Access Compliance Report

Public Rights-of-Way

(Curb Ramps)

Intersection ID: 10019500	Main Street: ALICE_MCGINN_DR	Cross Street: N/A	Location: SE
ADA ID: CCEB704088E9	Ramp Type: Perp	Initial Pass/Fail: Fail	Overall Compliance: No
Severity Score: 13.75			
Codes/Mitigation Info/Possible Solution		Field Measurements/Component Compliance

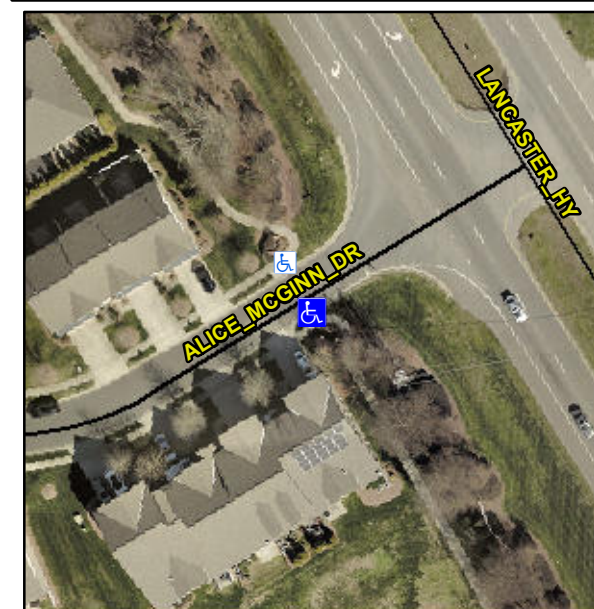
Not Found, R304.2.2

Compliance	Description	Data	Compliance	Description	Data
N/A	Ramp Length (in)	48.0	No	Ramp Slope (%)	8.7
Yes	Ramp Width (in)	48.0	Yes	Ramp XSlope (%)	3.4
N/A	Flare Type LT	N/A	N/A	Flare Type RT	N/A
N/A	Flare Slope LT (%)	N/A	N/A	Flare Slope RT (%)	N/A
N/A	Flare Traversable LT?	N/A	N/A	Flare Traversable RT?	N/A
N/A	Landing Length (in)	N/A	N/A	DWS Provided?	N/A
N/A	Landing Width (in)	N/A	N/A	DWS Contrast?	N/A
N/A	Landing Slope (%)	N/A	N/A	DWS Length (in)	N/A
N/A	Landing X Slope (%)	N/A	N/A	DWS Full Width?	N/A
N/A	Landing Curb? (Y/N)	N/A	N/A	DWS Offset (in)	N/A
N/A	Shared Landing?	N/A			
N/A	Gutter Ponding?	N/A	N/A	Gutter Slope (%)	N/A
N/A	Gutter Lip Ht (in)	N/A	N/A	Gutter X Slope (%)	N/A
N/A	Painted X Walk1?	No	N/A	Painted X Walk2?	N/A
	X Walk 1 Direction	To NW		X Walk 2 Direction	N/A
N/A	X Walk 1 Width (in)	N/A	N/A	X Walk 2 Width (in)	N/A
	X Walk 1 Slope (%)	2.4		X Walk 2 Slope (%)	N/A
	X Walk 1 X Slope (%)	4.1		X Walk 2 X Slope (%)	N/A

Remove & Replace Entire Ramp.
